SUBJECT: ISSUANCE OF AMENDMENT NO. 100 TO FACILITY OPERATING LICENSE NPF-9 AND  
AMENDMENT NO. 82 TO FACILITY OPERATING LICENSE NPF-17 - MCGUIRE  
NUCLEAR STATION, UNITS 1 AND 2 (TACS 71963/71964)

AMENDMENT NO. 100 TO FACILITY OPERATING LICENSE NPF-9 - McGuire Nuclear Station, Unit 1  
AMENDMENT NO. 82 TO FACILITY OPERATING LICENSE NPF-17 - McGuire Nuclear Station, Unit 2

SAFETY EVALUATION BY THE OFFICE OF NUCLEAR REACTOR REGULATION  
RELATED TO AMENDMENT NO. 100TG FACILITY OPERATING LICENSE NPF-9  
AND AMENDMENT NO. 82 TO FACILITY OPERATING LICENSE NPF-17

MCGUIRE NUCLEAR STATION, UNITS 1 AND 2

FIGURE 3.4-2 MCGUIRE UNIT 1, REACTOR COOLANT SYSTEM, HEATUP LIMITATIONS  
NRC RG 1.99 REV 2

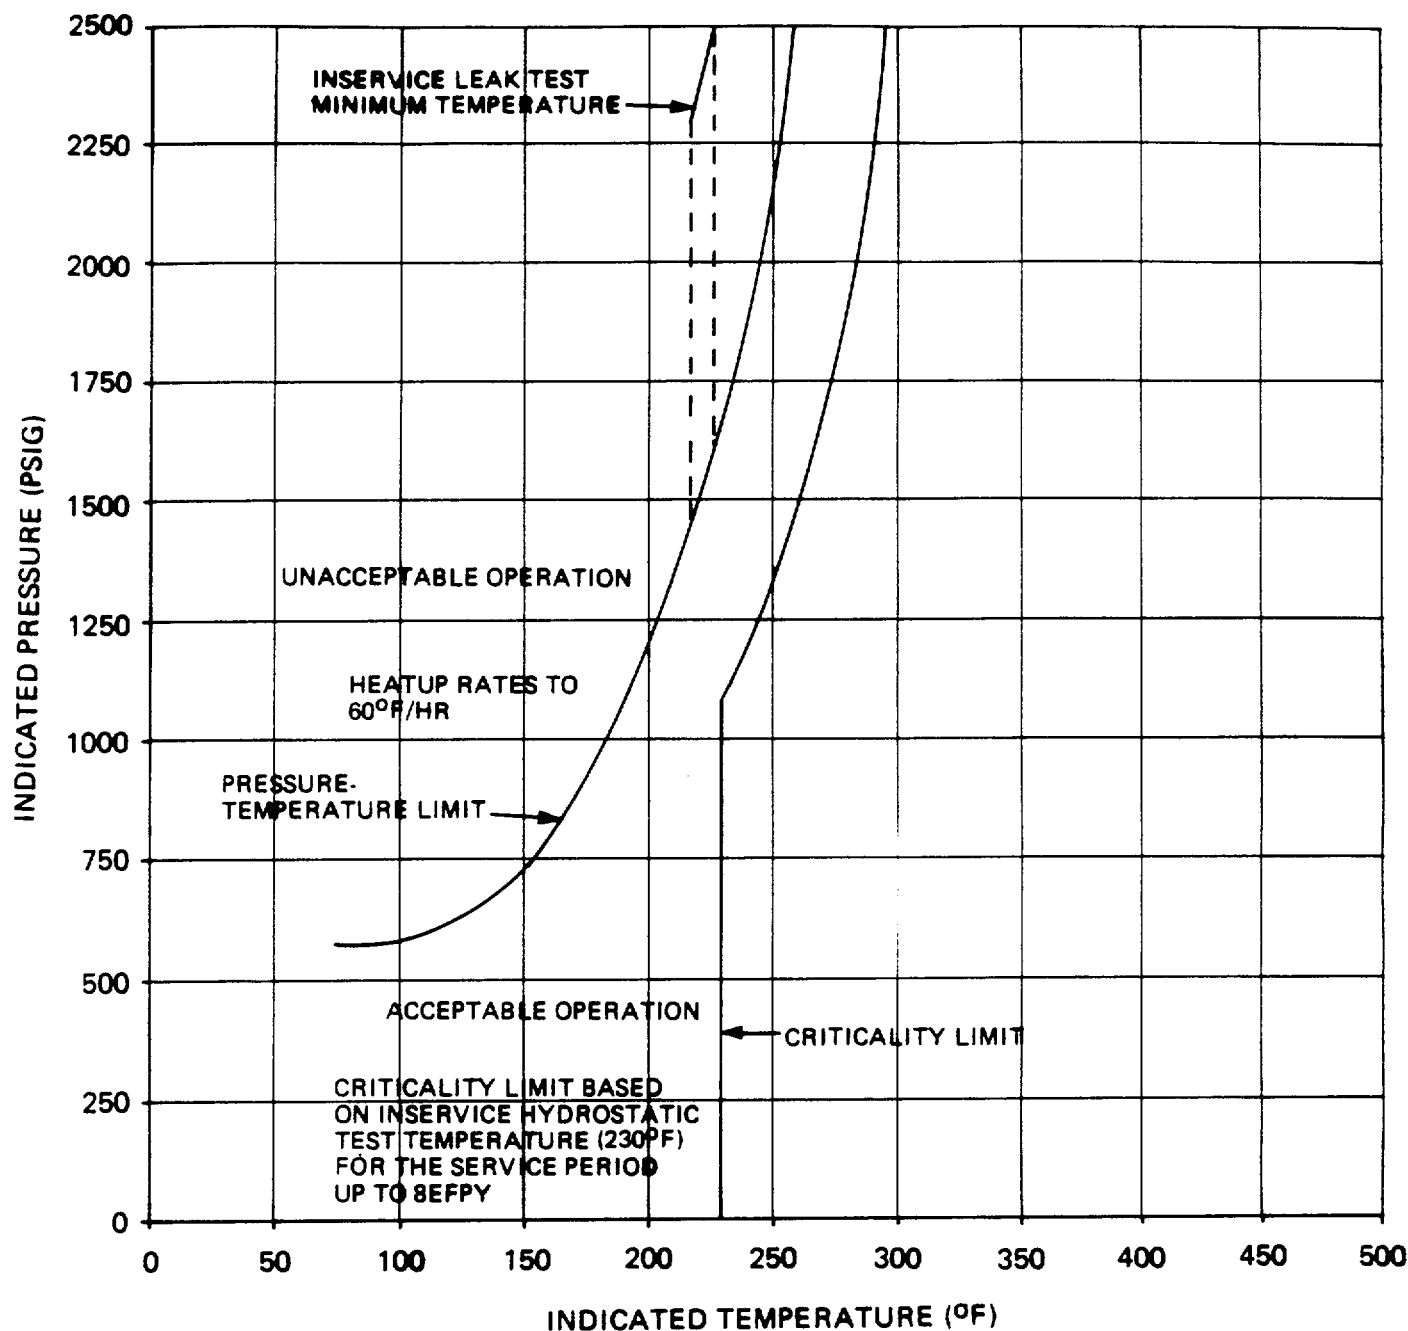
For McGuire Unit 1, these amendments replace the existing reactor coolant system (RCS) heatup and cooldown curves, referenced by TS 3/4.4.9.1, with new curves shown on TS Figures 3.4.2 and 3.4-4, respectively. As before, the new curves contain margins of 10° F and 60 psig for possible instrument errors, and are applicable for the service period up to ten effective full power years (EFPY). The new curves are based upon a Westinghouse Report, "McGuire Unit 1 Reactor Vessel Heatup and Cooldown Limit Curves for Normal Operation" dated November 1988 and forwarded as Attachment 5 of the licensee's January 22, 1989 submittal. The method for predicting radiation embrittlement (i.e., determination of adjusted reference temperature for vessel beltline material) in this Westinghouse report is based upon Regulatory Guide (RG) 1.99, Revision 2. The associated maximum heatup or cooldown rate during normal operations as specified by TS

The new RCS heatup and cooldown curves for McGuire Unit 1 are needed because the existing TS limits, based on analysis of surveillance Capsule U as documented in the licensee's letter of April 5, 1985 and Westinghouse Report WCAP-10786, are valid up to 4.86 EFPY. At the end of fuel cycle 5 (October 1988), McGuire Unit 1 had reached about 4.3 EFPY and was projected to reach the existing limit by about June 1989. Thus, absent this amendment, the existing Unit 1 heatup and cooldown P-T limits would become non-conservative about mid-1989.

CURVE APPLICABLE FOR HEATUP RATES UP TO 60°/HR FOR THE SERVICE PERIOD UP TO 10 EFY CONTAINS MARGIN FOR POSSIBLE INSTRUMENT ERRORS.

MATERIAL BASIS  
CONTROLLING MATERIAL—WELD METAL  
COPPER CONTENT—0.30wt%  
PHOSPHORUS CONTENT—0.013wt%  
RT<sub>NDT</sub> INITIAL—0°F 1/4T, 165.5°F  
RT<sub>NDT</sub> AFTER 10 EFY 3/4T, 113°F

The staff has reviewed the P-T limits and curves for McGuire Unit 1, including the November 1988 Westinghouse report. We find that the fracture-toughness properties of the ferritic material in the reactor coolant pressure boundary have been determined in accordance with Standard Review Plan Chapter 5.3.2 and that the approach defined in Appendix G to the ASME Code Section III was followed to calculate the allowable limit curves for heatup and cooldown rates. Accordingly, since the new curves are based on results of capsule analyses performed with NRC approved methods, and since the new curves are conservative with respect to the existing P-T operating limits, we find that they appropriately reflect the change in material toughness of the reactor vessel due to irradiation effects and are acceptable.

**FIGURE 3.4-3 MCGUIRE UNIT 2, REACTOR COOLANT SYSTEM, HEATUP LIMITATIONS APPLICABLE FOR THE FIRST 8 EFPY**

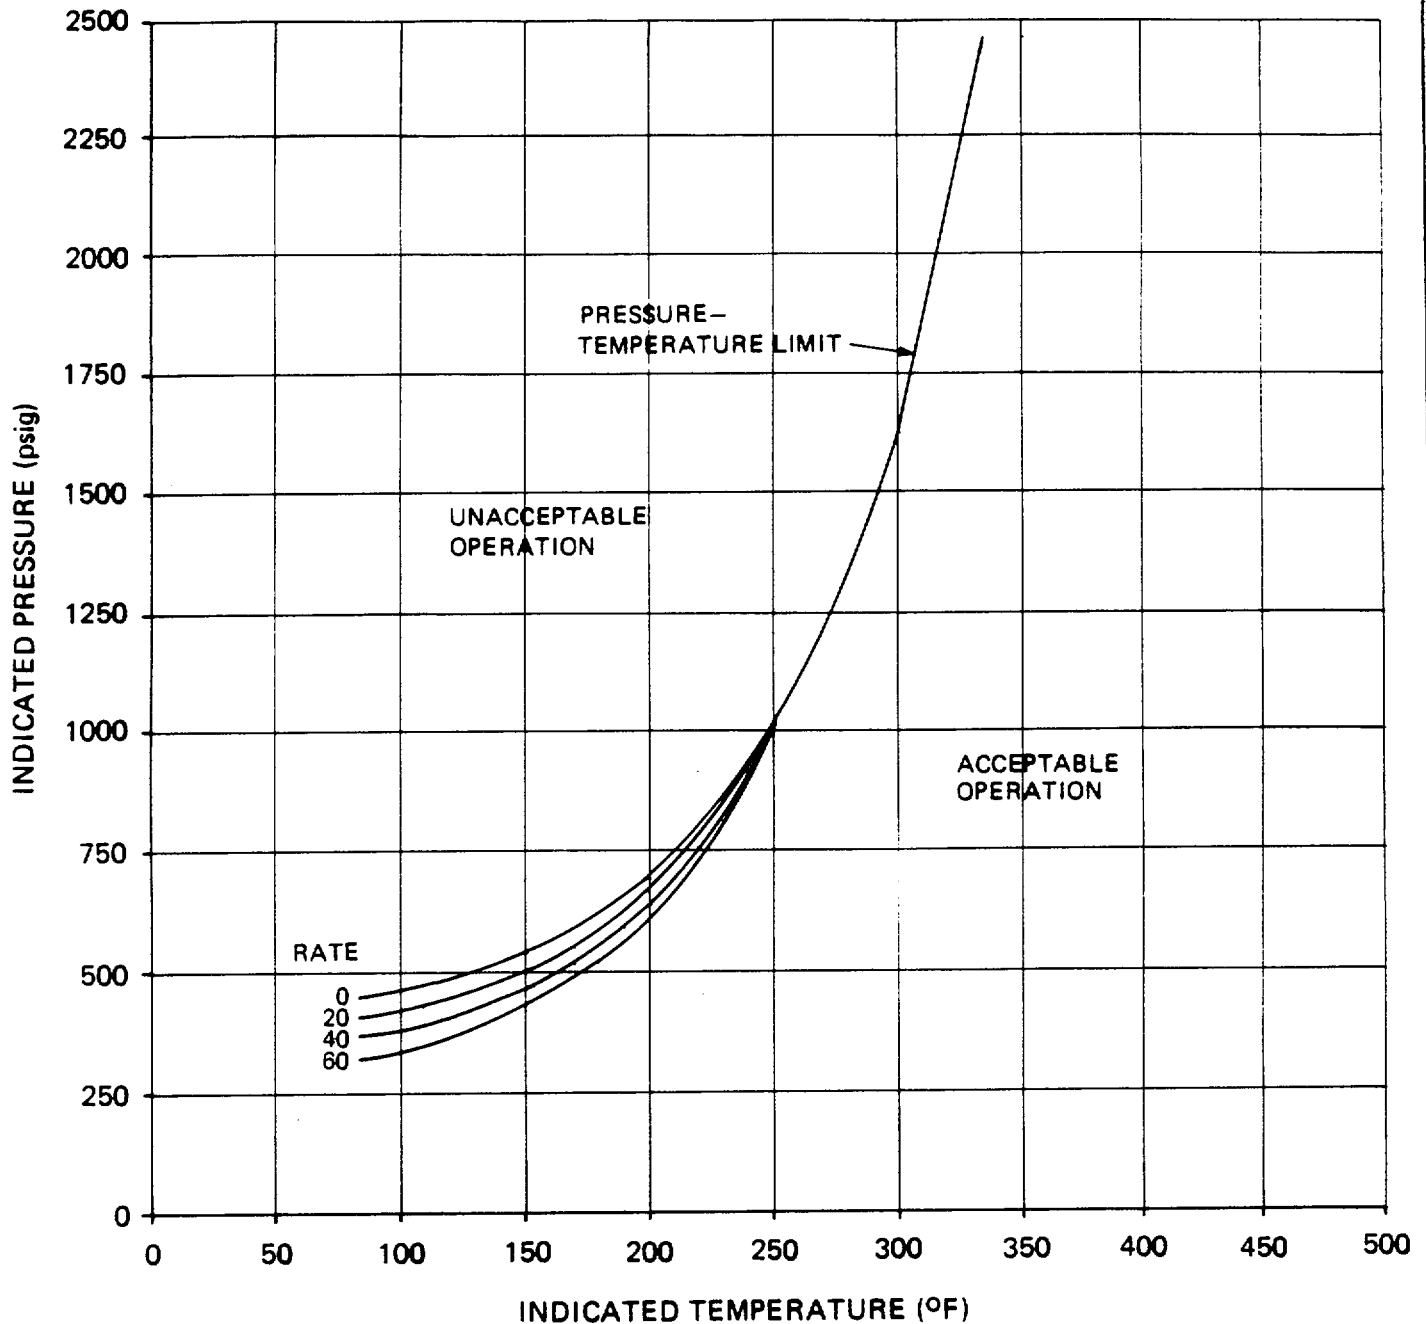
For McGuire Unit 2, these amendments replace the existing RCS heatup and cooldown curves with new curves shown on TS Figures 3.4-3 and 3.4-5 respectively. The new curves are needed to reflect adjustments to existing limits based upon analysis of the last surveillance capsule removed from the Unit 2 vessel. Results of the analysis of this last capsule, Capsule V, were provided by the licensee's letter of April 2, 1986 and by WCAP-11029. As before, the new curves contain margins of 10° F and 60 psig for possible instrument errors.

The new curves are proposed to be applicable only for the first 8 EFPY. The curves provided in WCAP-11029 were developed using Revision 1 to RG 1.99. As with Unit 1 curves, the associated maximum heatup or cooldown rate during normal operations as specified by TS 3.4.9.1a and TS 3.4.9.1b, respectively, is decreased from 100° F per hour to 60° F per hour, which is more in line with Duke's own administrative cooldown limit of 50° F per hour.

**CURVES APPLICABLE FOR HEATUP RATES UP TO 60°F/HR FOR THE SERVICE PERIOD UP TO 8 EFPY AND CONTAINS MARGINS OF 10°F AND 60 PSIG FOR POSSIBLE INSTRUMENT ERRORS.**

**MATERIAL BASIS**  
**CONTROLLING MATERIAL—REACTOR**  
**VESSEL INTERMEDIATE SHELL 05**  
**COPPER CONTENT 0.16**  
**RT<sub>NDT</sub> INITIAL -4°F**  
**RT<sub>NDT</sub> AFTER 8 EFPY**  
**1/4T, 86°F**  
**3/4T, 36°F**

\*Approved by NRC for first 5 EFPY or completion of the refueling outage at the end of fuel cycle 6, based on Generic Letter 88-11.

FIGURE 3.4-4 MCGUIRE UNIT 1, REACTOR COOLANT  
SYSTEM, COOLDOWN LIMITATIONS  
NRC RG 1.99 REV 2  
APPLICABLE FOR THE FIRST 10 EFPY

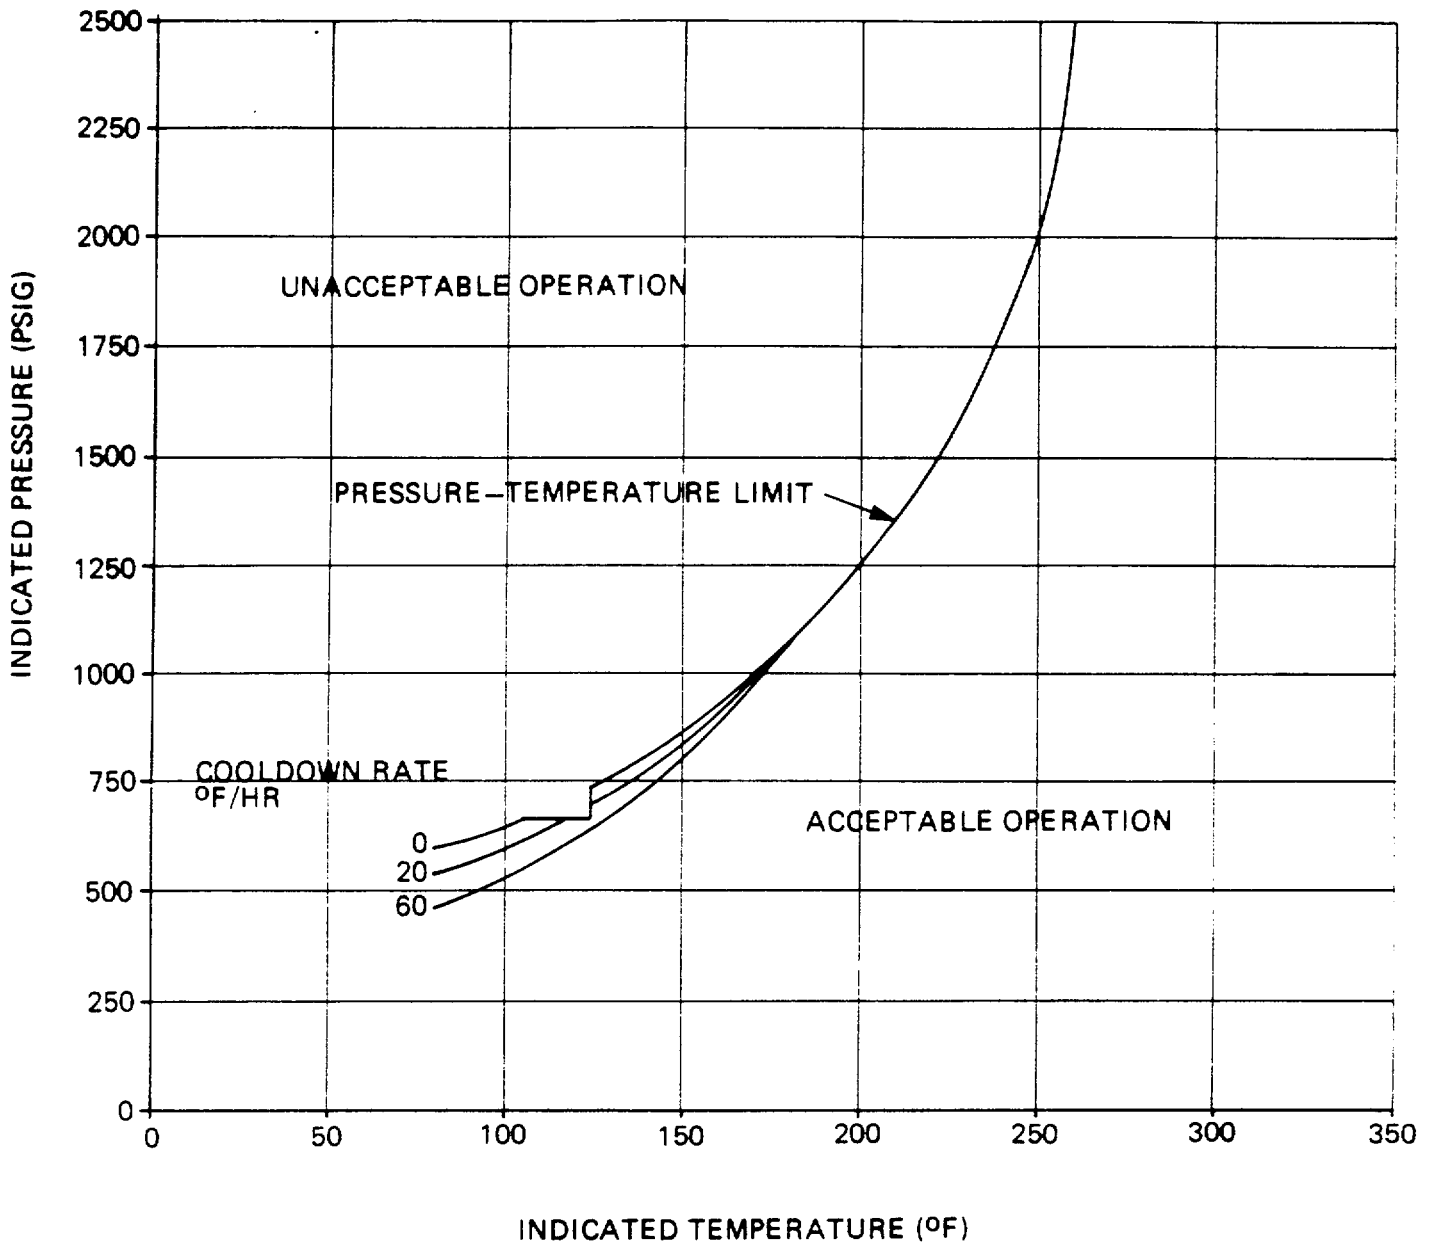
3.4.9.1a and TS 3.4.9.1b, respectively, is decreased from 100° F per hour to 60° F per hour. Duke's own associated administrative cooldown limit is not affected by these amendments and continues to be 50° F per hour.

CURVES APPLICABLE FOR COOLDOWN  
RATES UP TO 50°F/HR FOR THE  
SERVICE PERIOD UP TO 10 EFPY  
CONTAINS MARGIN FOR POSSIBLE  
INSTRUMENT ERRORS.

MATERIAL BASIS  
CONTROLLING MATERIAL—WELD METAL  
COPPER CONTENT—0.30wt%  
PHOSPHORUS CONTENT—0.013wt%  
RT<sub>NDT</sub> INITIAL—0°F 1/4T, 165.5°F  
RT<sub>NDT</sub> AFTER 10 EFPY 3/4T, 113°F
